## ***Interactive comment on “Topographical changes caused by moderate and small floods in a gravelly ephemeral river – 2D morphodynamic simulation approach” by Eliisa Lotsari et al.***

**Eliisa Lotsari et al.**

Received and published: 7 December 2017

**Fig. 1.**

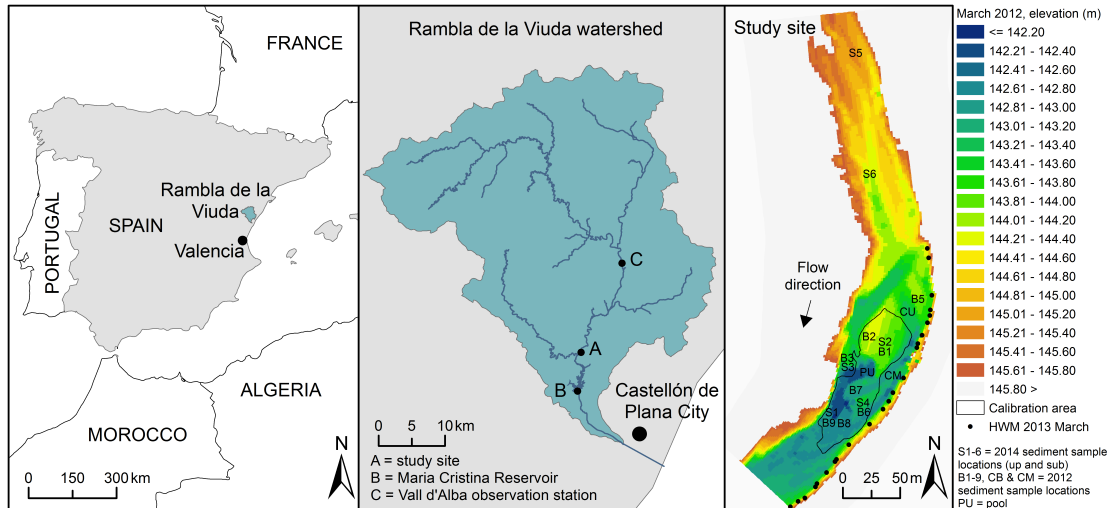
RC: Page 4, Figure 1 – It would be more useful to see the reach in context with the wider catchment here than its rough location in Spain. How big is the catchment and where is the reach in relation to the gauging station used?

AC: The detailed gauging station and study site locations have been added into the new version of the Fig. 1.

**Fig. 3.**

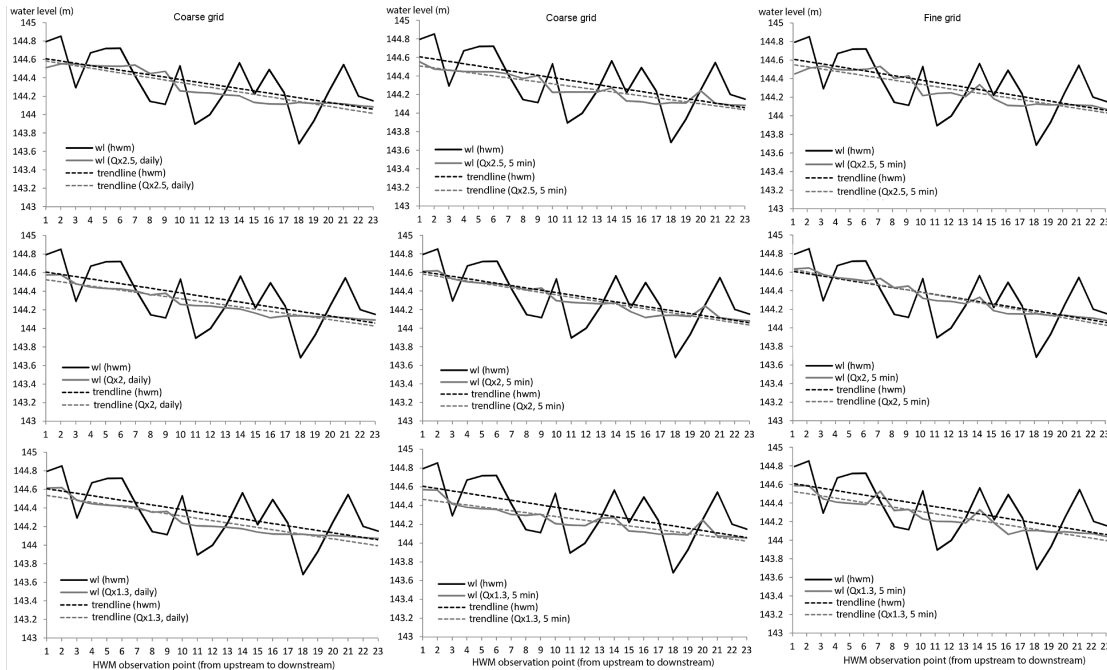
RC: Figure 3 legend: More commentary is needed. Abbreviations need to be stated. A location map would be useful.

RC: Figure 3- it is unclear how this relates – more detailed description needed

AC: We added more explanation of the abbreviations to the figure caption. We also added the locations of the HWM measurements in the Fig.1.

The caption of the Fig. 3. is now as follows:” Figure 3: The hydrodynamic calibration results based on the coarse grid (1.51–5.31 m cells) and fine grid (0.76–3.03 m cells). In this figure, the high-water marks (HWM) and simulated water levels are presented. In addition, the trendlines fitted along these measurements and simulation results are shown. These calibration results of the fine grid were previously presented in Calle et al. (2015) by the same authors. The Qx1.3, Qx2 and Qx2.5 refer to the discharges scaled to match the peak discharge at the study site. Daily and 5 min refer to the observation interval of discharges at Vall d’Alba station. wl = water level based on HWMs and simulations, trendline = the trendline fitted in the measured HWMs and the simulation results. The location of these HWM measurement points have been shown in the Fig. 1.“

AC: We have clarified the figure caption: “Figure 3: The hydrodynamic calibration results based on the coarse grid (1.51–5.31 m cells) and fine grid (0.76–3.03 m cells). In this figure, the high-water marks (HWM) and simulated water levels are presented. In addition, the trendlines fitted along these measurements and simulation results are shown. These calibration results of the fine grid were previously presented in Calle et al. (2015) by the same authors. The Qx1.3, Qx2 and Qx2.5 refer to the discharges scaled to match the peak discharge at the study site. Daily and 5 min refer to the observation interval of discharges at Vall d’Alba station. wl = water level based on HWMs and simulations, trendline = the trendline fitted in the measured HWMs and the simulation results. The location of these HWM measurement points have been shown in the Fig. 1.”

**Fig. 4.**

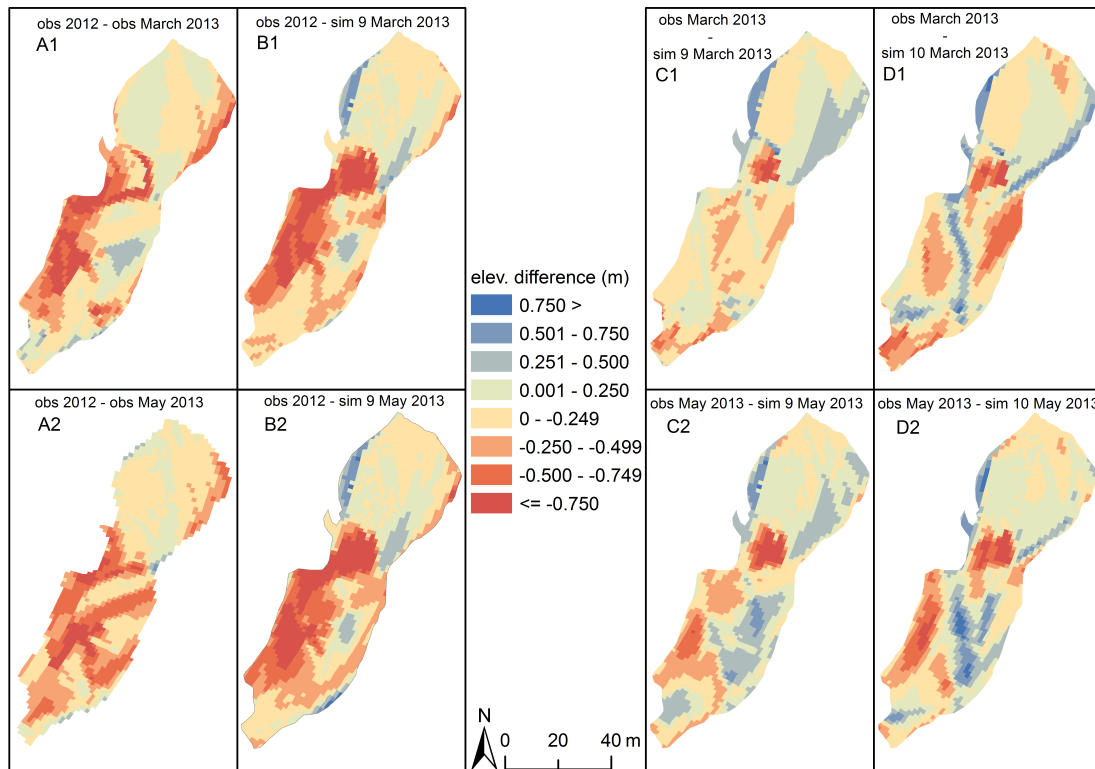
RC: Figures 4-6 – it would have been useful to show the ‘analysed area in context with the broader area studied

AC: We had calibrated the model based on this area, where we had data from all the topography measurement times (2012, March 2013 and June 2013). Thus, the reason for showing the calibration area in these figures is, because we were able to perform the goodness-of-fit only in this area. We have modified the manuscript so that we are not anymore talking about the “analyzed area” but about “calibration area”. We have now added the whole simulation area to in the new Figs. 6 and 7, i.e. in the results section related to the morphodynamic analyses. In these two figures, the results of the best simulation are shown. We are now showing the whole simulation area also in Fig. 1. We have moved the former Figs. 4-6 into the supplementary material (there Figs. 1-3), and present a new Fig. 4 (includes parts of former Fig. 6) in the main manuscript.

Fig. 7.

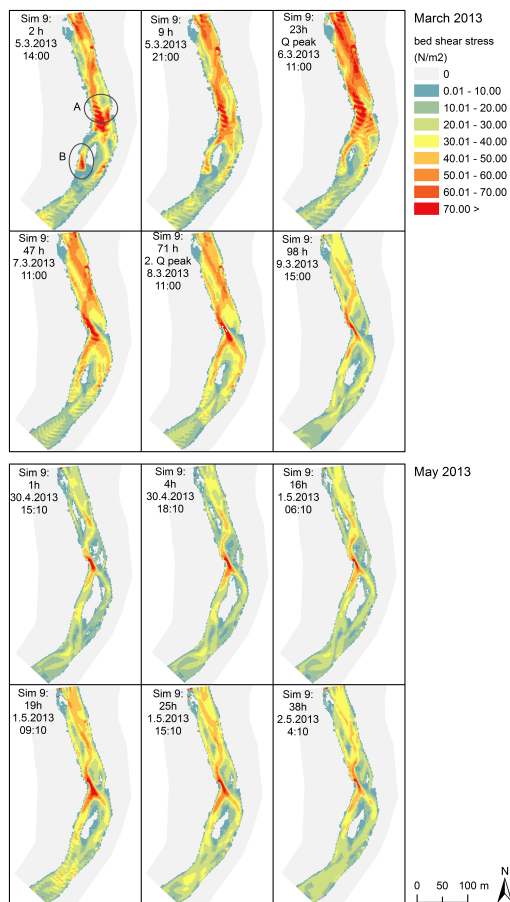
RC: Page 19 Lines 6 – 19 – would these plots have been better as hysteresis type plots so plotting Q against volumetric changes in bedload? You have not discussed hysteresis at all? The same comments apply for section 4.2.2 Figure 7 – you need axis labels, especially for the Y axis- what is it showing?

The units of the parameters (Y-axis) had been presented in the legend (former Fig. 7 -> now Fig. 5). We have now added both of the units also in the Y-axis too. We have also added a new Fig. 6 to show the spatial bed elevation changes between the key time steps, which are presented in Fig. 5.
